Contract No. 24111 PP0
Project No. 300200006
Wilkens Police Precinct New Building (Leed Silver Certification) –
901 Walker Avenue, Catonsville, Maryland 21228
Catonsville – District 1c1

ADDENDUM NO. 5

DATE: 11/10/2025

Wilkens Police Precinct New Building (24111 PP0)

TEMPORARY GRAVEL ADA PARKING

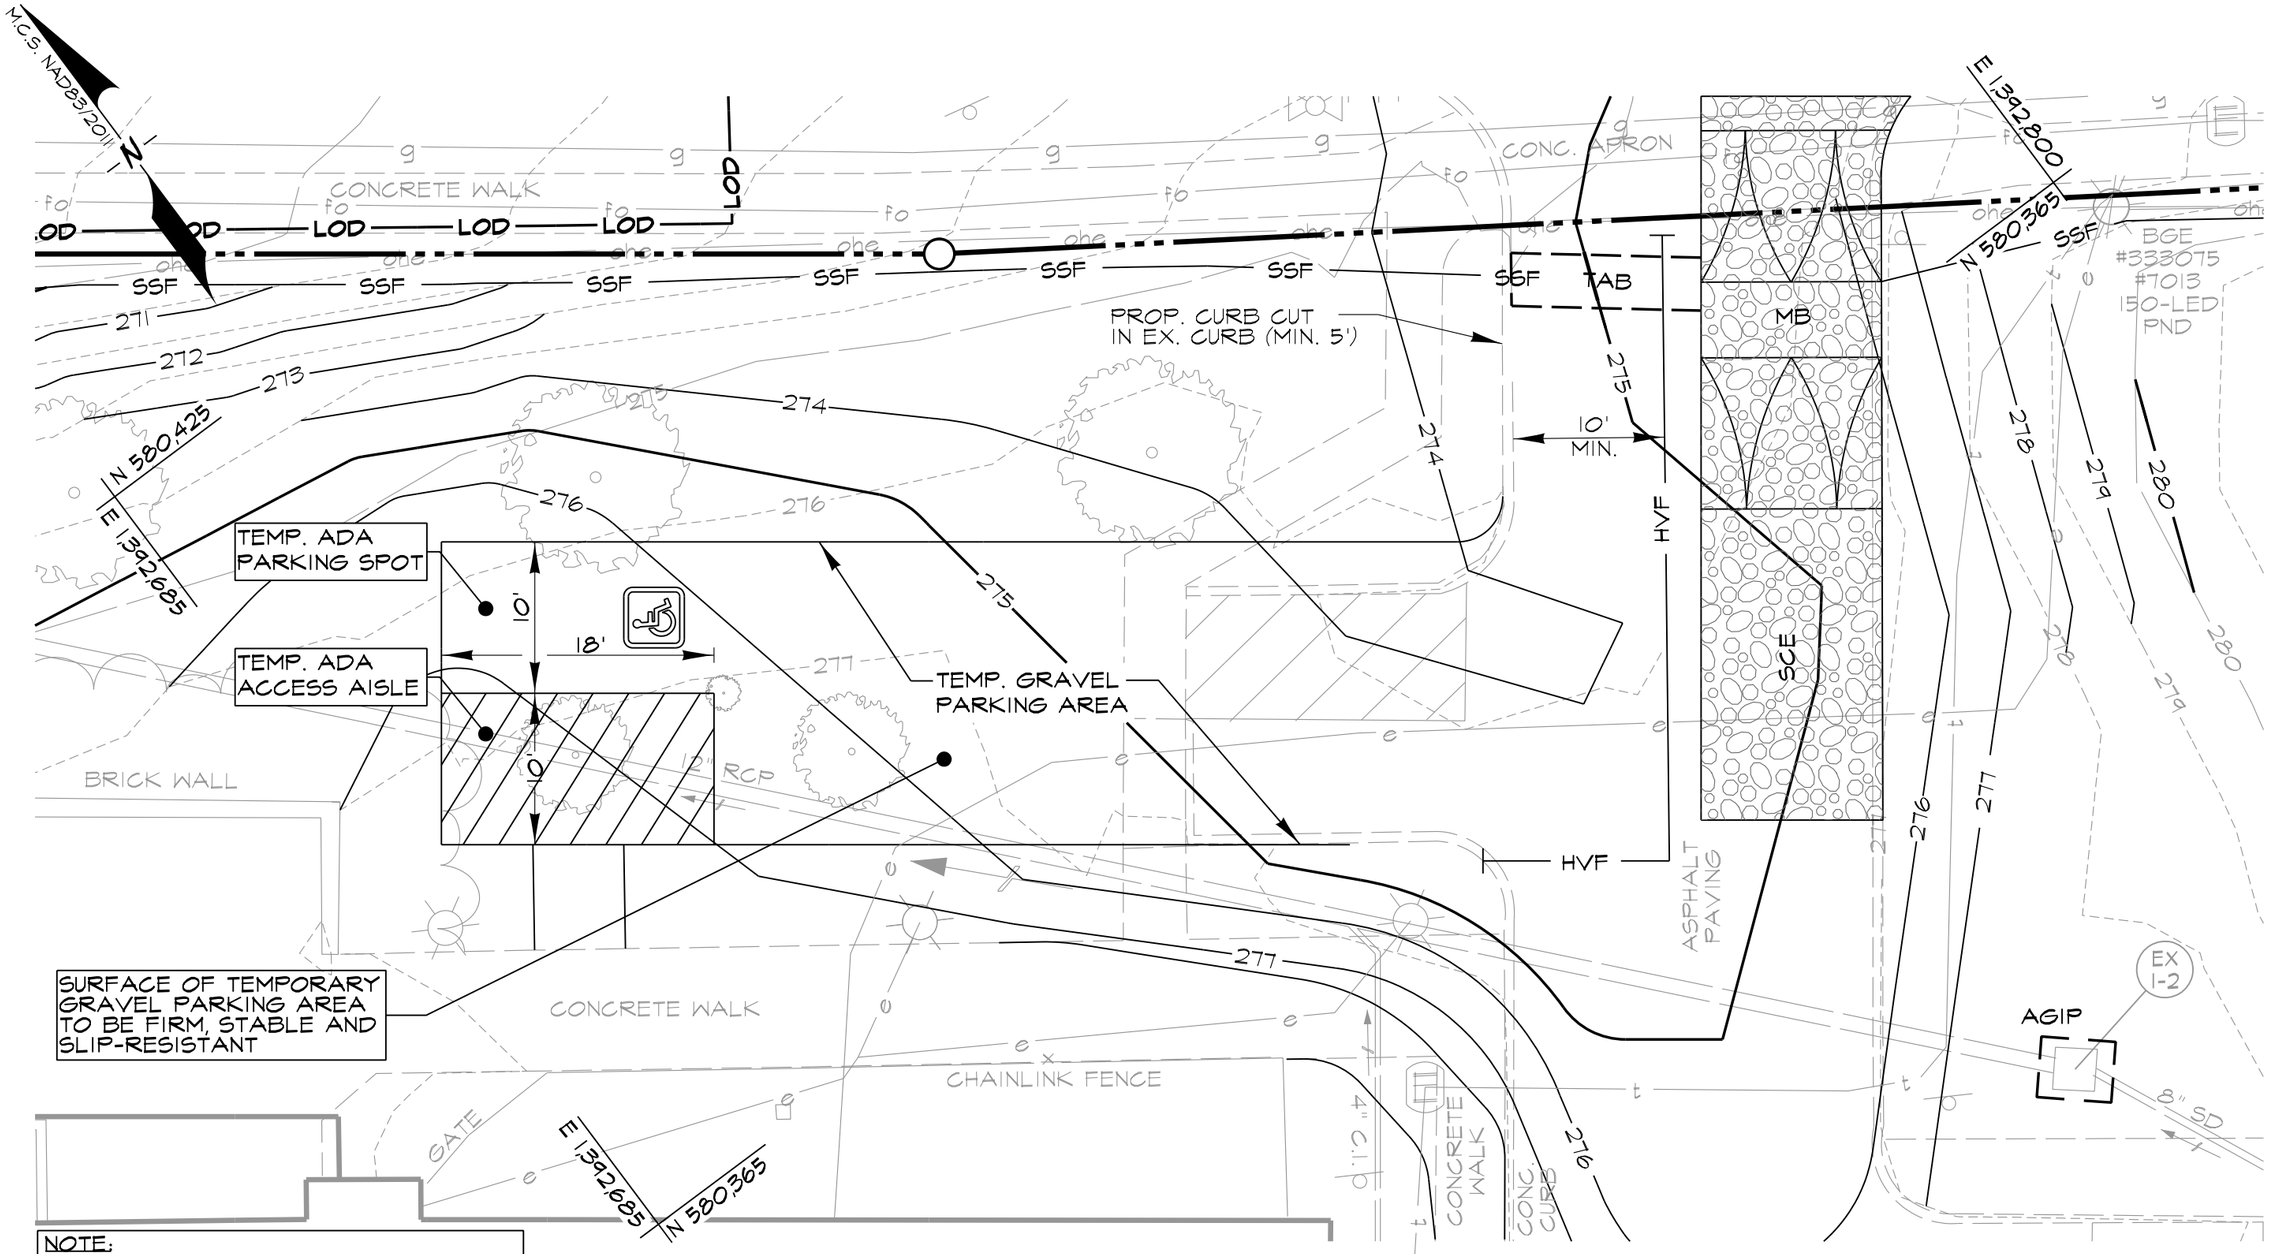
1. ***Question:*** *Does the County have a relocation plan for the police precinct including egress to/from old building to new building? If so, please provide and advise does the plan require ADA parking in the temporary parking area?*
   Response: *See attached EX1.00 depicting the ADA parking in the temporary lot.*

1 / C4.01 — ADA PARKING AREA
NOT TO SCALE

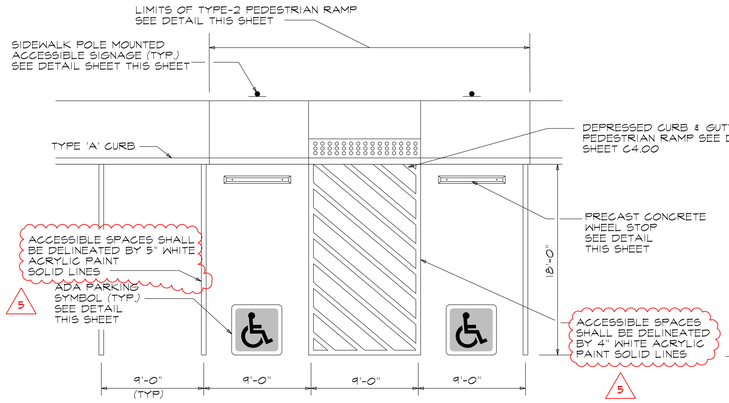
42. ***Question:*** *On drawing C4-01, drawing number 2024-1329 Sheet #16 of 302 On Site Detail for ADA parking area calls for 5" WHITE PAINTED striped lines. On C5-00 drawing number 2024-1331 sheet #18 of 302 in the striping and signage key letter D calls for 5" wide solid THERMOPLASTIC white line. Can you confirm if it is thermoplastic or paint?*
Response: *See attached Sheets C4.01 and C5.00 which have been revised to call for acrylic-based paint. This now corresponds to one of the options provided in spec section 32 17 23.*

75. ***Question:*** *Will the striping be done with Acetone paint or Extruded Thermoplastic paint?*
Response: *Paint shall be waterborne acrylic alkyd striping paint. See attached revised sheets C4.01 and C5.00.*

STRIPING AND SIGNAGE PLAN

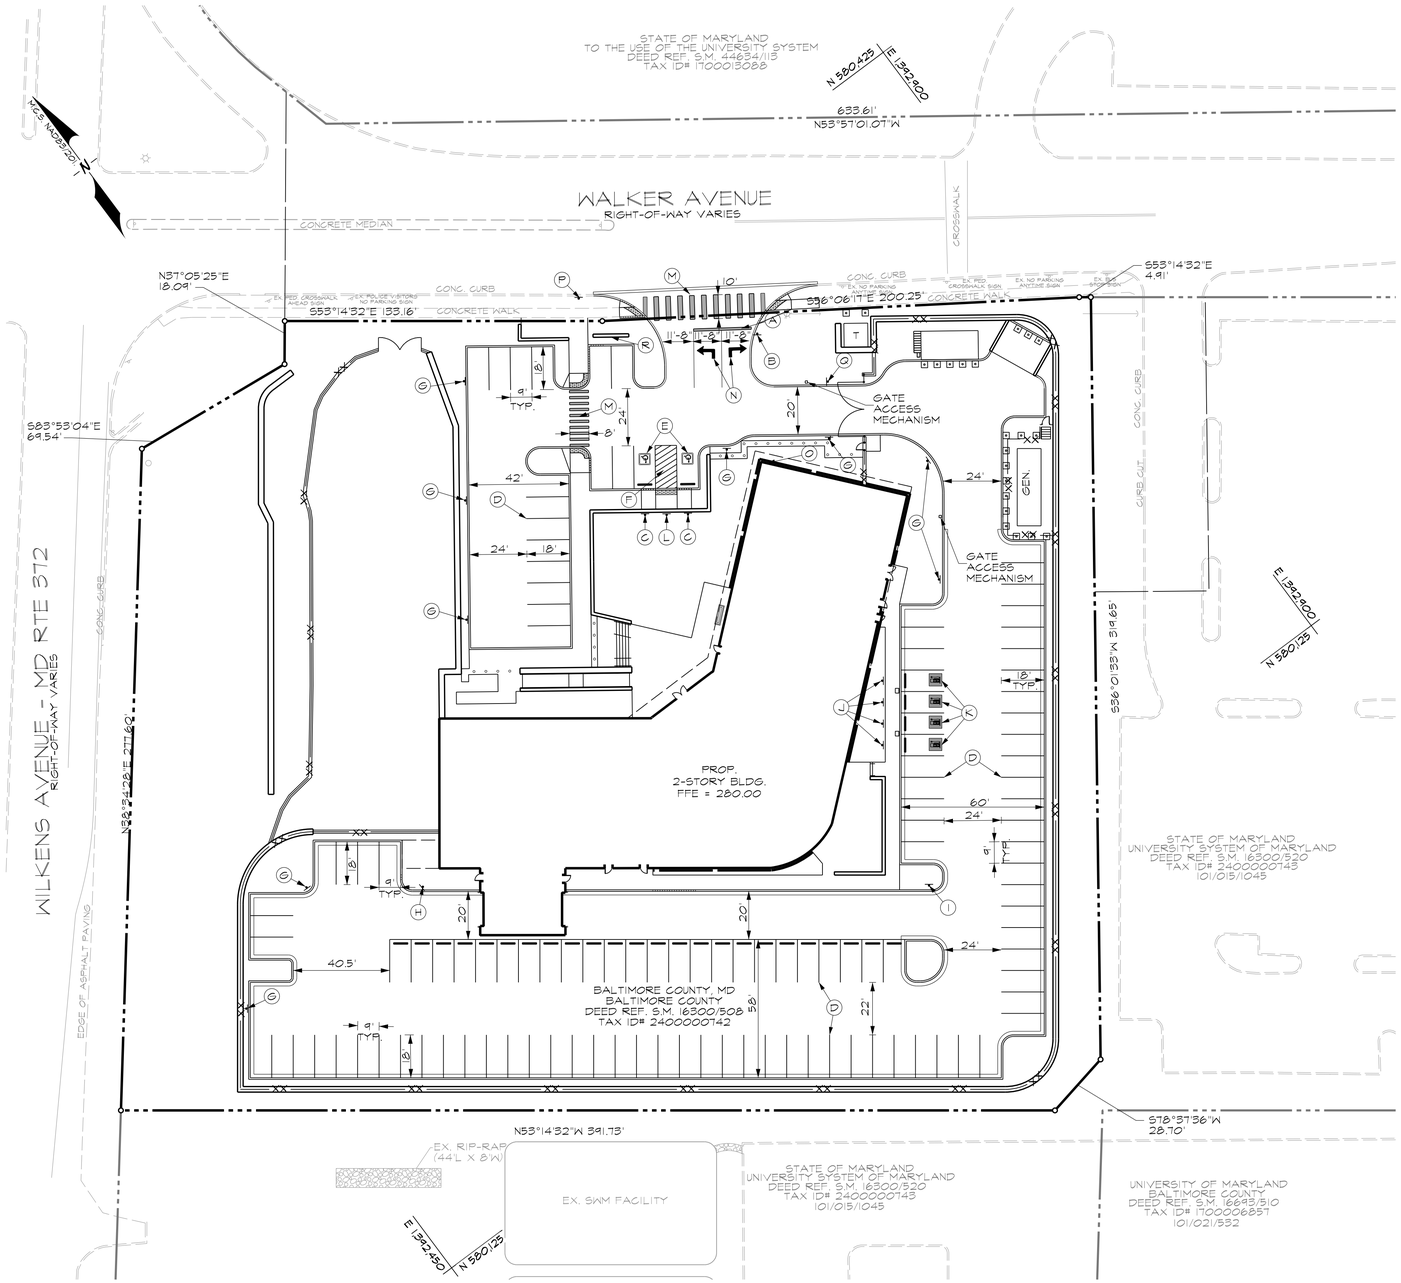
89. ***Question:*** *Parking space striping, HC symbols, Electric Vehicle symbols, crosshatched ADA no parking zone. The plans call for the parking spaces and crosshatched ADA no parking zone to be Thermoplastic. Specification 32 17 23-1 states latex or acrylic paint. Can the paint be used in lieu of Thermoplastic for these items.*
Response: *See attached revised sheets C4.01 and C5.00 which have been revised to call for acrylic based paint instead of thermoplastic. This now matches the acrylic option in section 32 17 23.*

- (D) 5" WIDE WHITE SOLID LINE, ACRYLIC-BASED PAINT (5)
- (E) ADA PARKING SYMBOL (SEE DETAIL SHEET C4.01)
- (F) 4" SOLID WHITE LINES (ACRYLIC BASED PAINT) WITH 30" SPACING AT 45° FROM PARKING SPACES / CURB

HARDSCAPE KEY

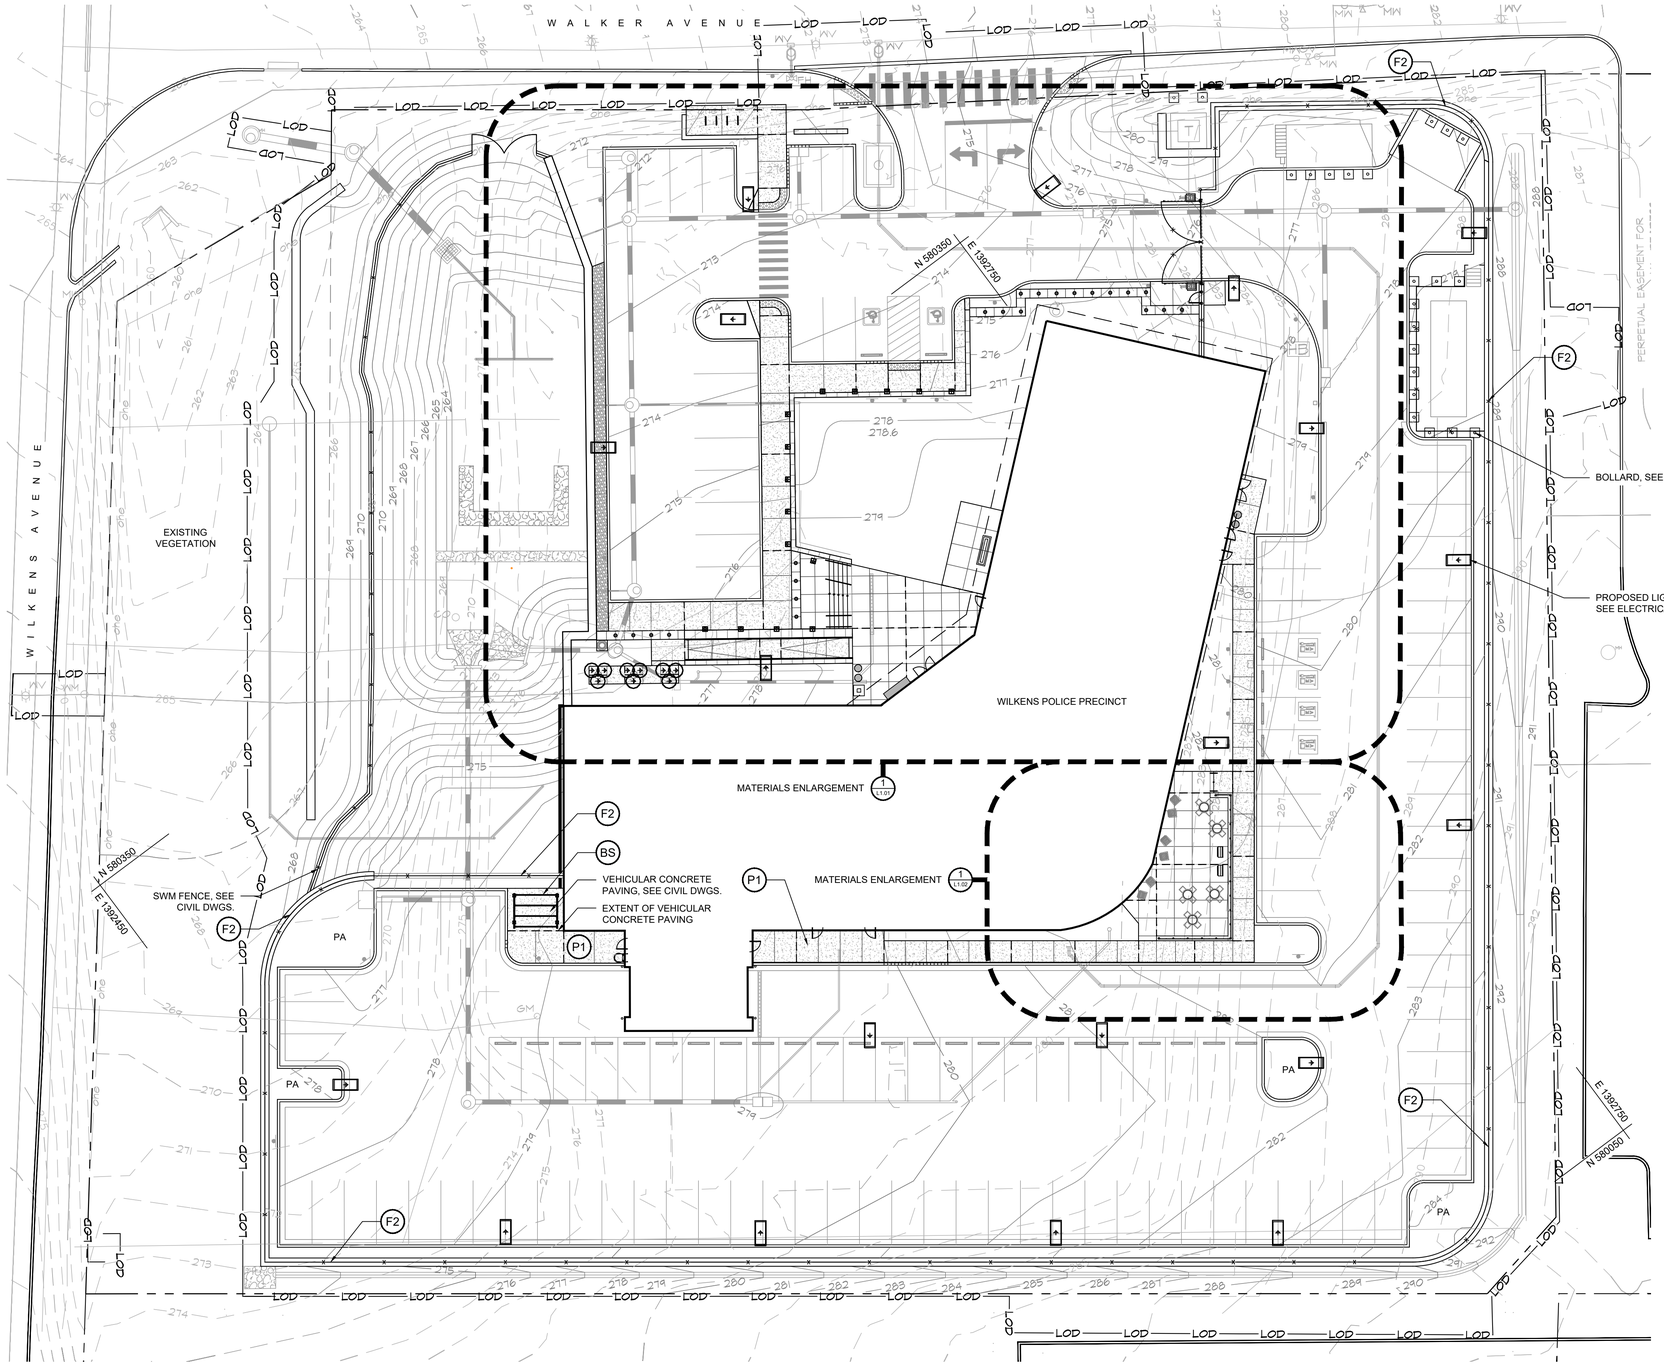
36. ***Question:*** *Section 323119-2 (2.2) DEC FENCES & GATES - Calls for 10' OC Post Spacing The detail on Sheet L1.00 Calls for 8'OC Post Spacing. Please clarify and confirm post spacing.*

Response: *MRA: F2 fence posts should be spaced at max 10' O.C. as outlined in specification 32 31 19 2.2.A, in the hardscape key on L1.01, and in detail 1/L5.04. Please see attached revised sheet L1.00 with post spacing noted as 10' O.C. in the hardscape key.*

1 ROOF PLAN
3/32" = 1'-0"

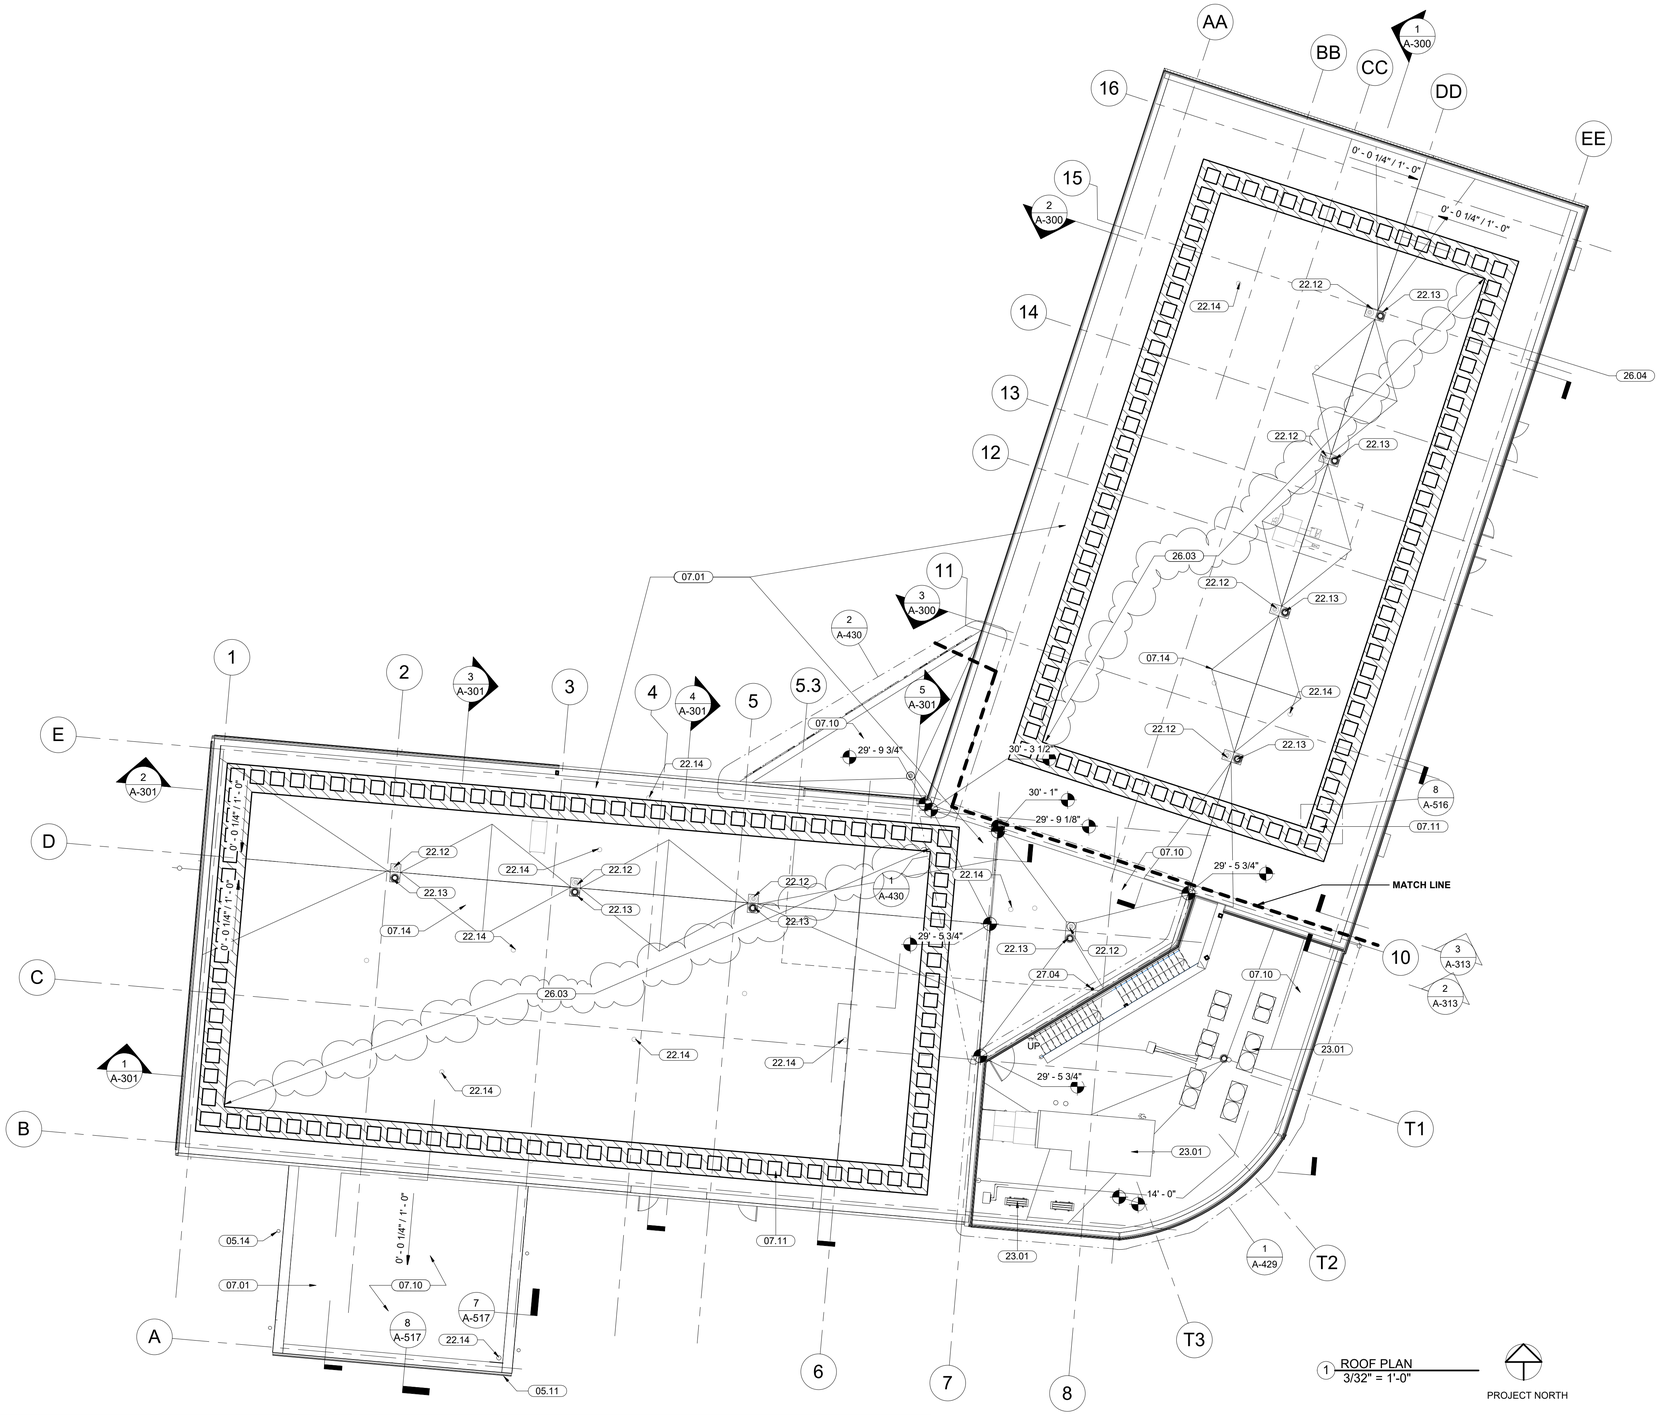
107. ***Question:*** *E209 & E210 show both sides of the building to be getting PV panels but on A103 it is only showing one side to receive PV panels. Please clarify which drawing is correct.*
Response: *PV to be located on both sides, see attached revised sheet A-103.*

1 ENLARGED FIRST FLOOR RCP - WING A
1/8" = 1'-0"

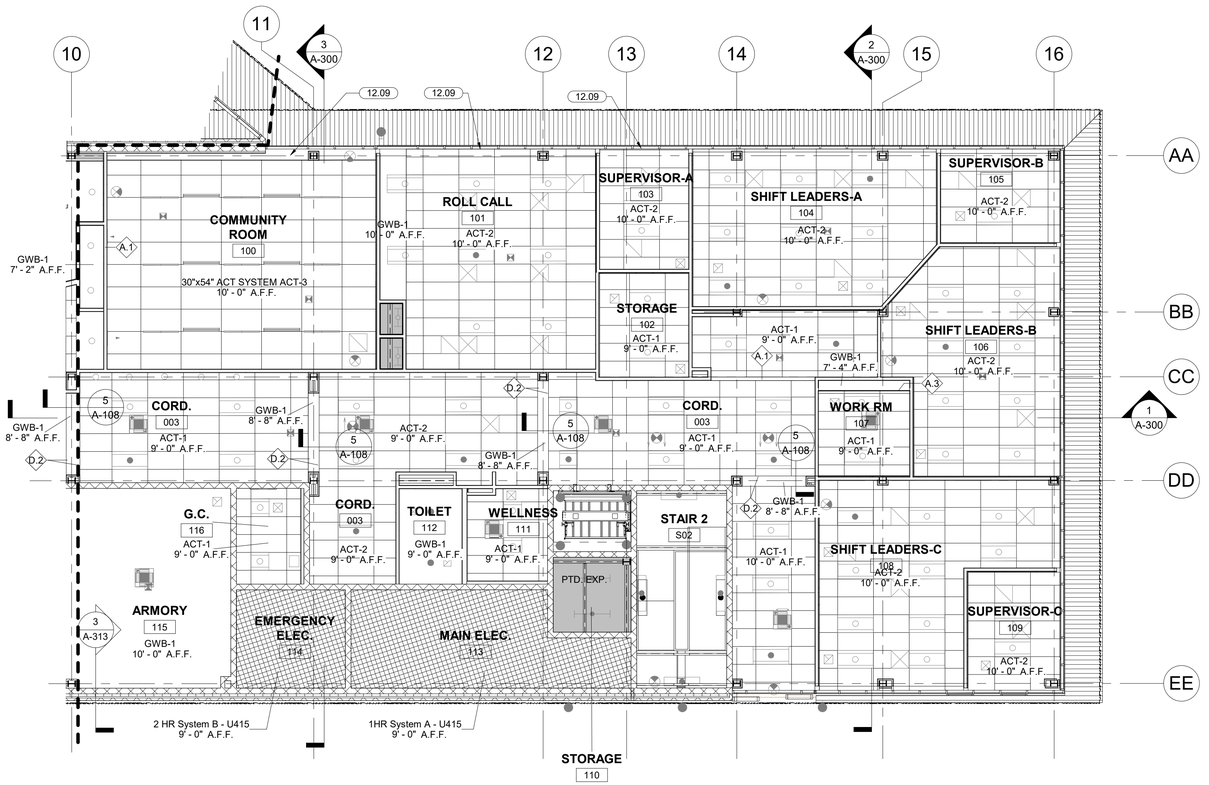
2024-1390	A-108	FIRST FLOOR RCP	Addendum 5
		Added notes identifying the metal deck in the details 6&7..	
2024-1392	A-110	ENLARGED FIRST FLOOR RCP - WING A	Addendum 5
		Revises Legend dimension to the product specified.
